Project	IEEE 802.16 Broadband Wireless Access Working Group < http://ieee802.org/16 >	
Title	Handoff SDL charts proposal	
Date Submitted	2004-03-04	
Source(s)	<p>Itzik Kitroser Yossi Segal Yigal Leiba Zion Hadad Runcom Technologies Ltd. 2 Hachoma St. 75655 Rishon Lezion, Israel</p>	<p>Voice: +972-3-9528440 Fax: +972-3-9528805 mailto:itzikk@runcom.co.il mailto:yossis@runcom.co.il mailto:yigall@runcom.co.il mailto:zionh@runcom.co.il</p>
Re:	Letter Ballot #14	
Abstract	This document presents SDL charts that describes the handoff process.	
Purpose	Integration into TGe draft.	
Notice	This document has been prepared to assist IEEE 802.16. It is offered as a basis for discussion and is not binding on the contributing individual(s) or organization(s). The material in this document is subject to change in form and content after further study. The contributor(s) reserve(s) the right to add, amend or withdraw material contained herein.

Handoff SDL charts proposal

2. Proposed changes

Figure 0h—MSS handoff locally initiated transaction begin state flow diagram

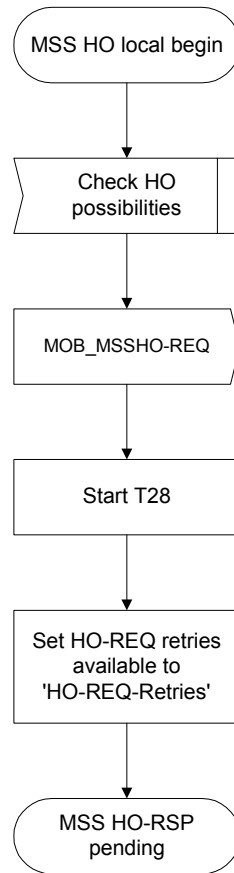
Figure 0h shows the SDL of an MSS initiating handoff with the BS.

Figure 0i—locally initiated transaction MOB_BSHO-RSP pending state flow diagram

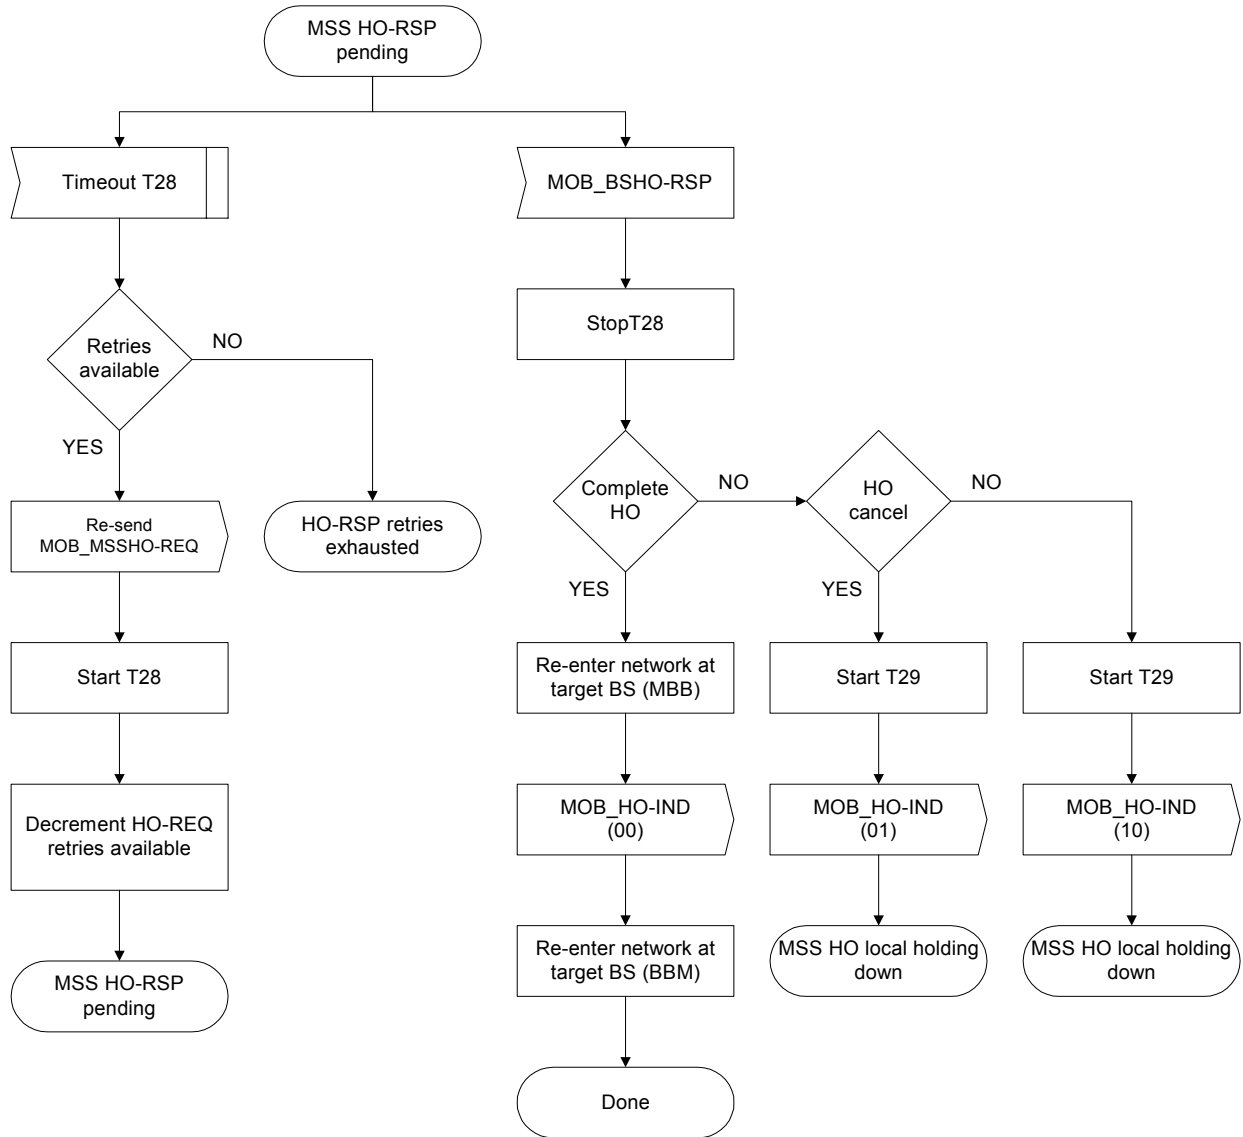
Figure 0i shows the SDL of an MSS waiting for a response from the BS, in addition it present the case in which the MSS has decided to stop the handoff in the middle of the process.

Figure 0j—MSS Handoff locally initiated transaction holding state flow diagram

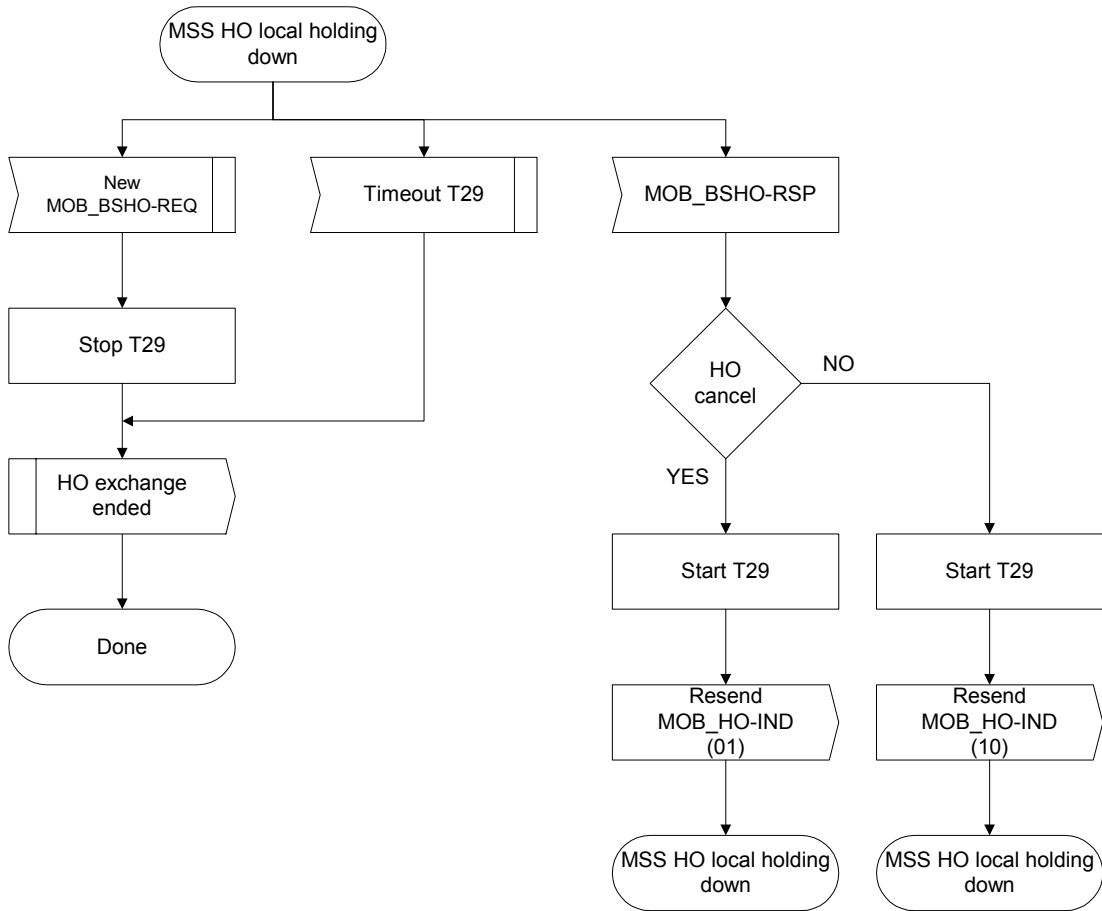
Figure 0j shows the SDL of an MSS following a canceling of the handoff and ensuring that the MOB_HO-IND message was received by the BS (by expiration of T29 timeout). While waiting, if new handoff process is required, the MSS shall stop T29 timer without waiting.
